REV. 1 2/22/21

119 TWIN FIELDS DR  
 FUQUAY VARINA NC  
 SCALE: 1/4" = 1'-0"

Roof build @ 119 Twin Fields Dr

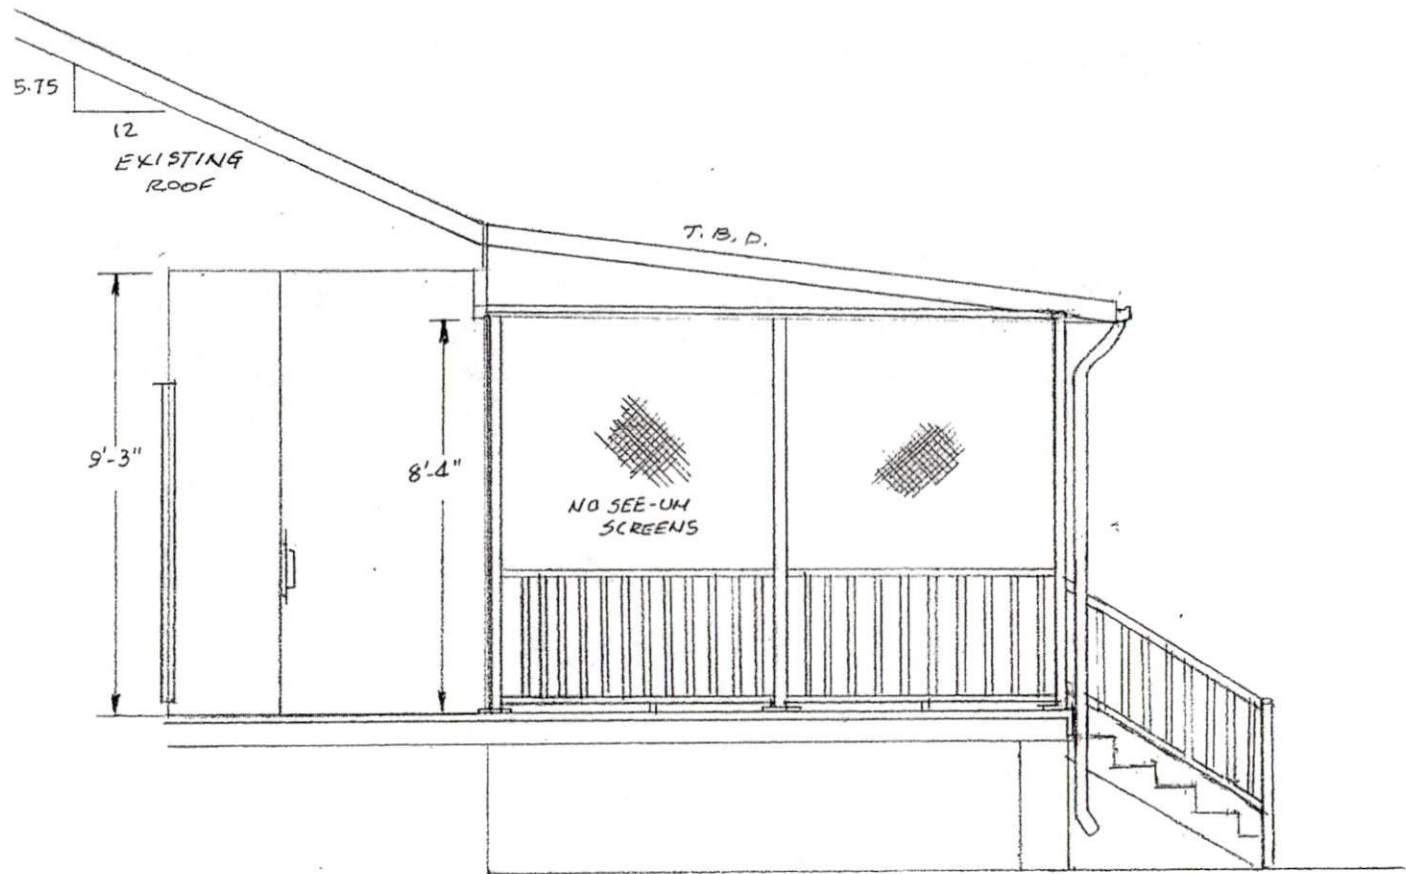
- 1. RELOCATED STAIRS
- 2. CHANGED DOOR SWING
- 3. LOCATION OF CEILING FAN OUTLET BOX
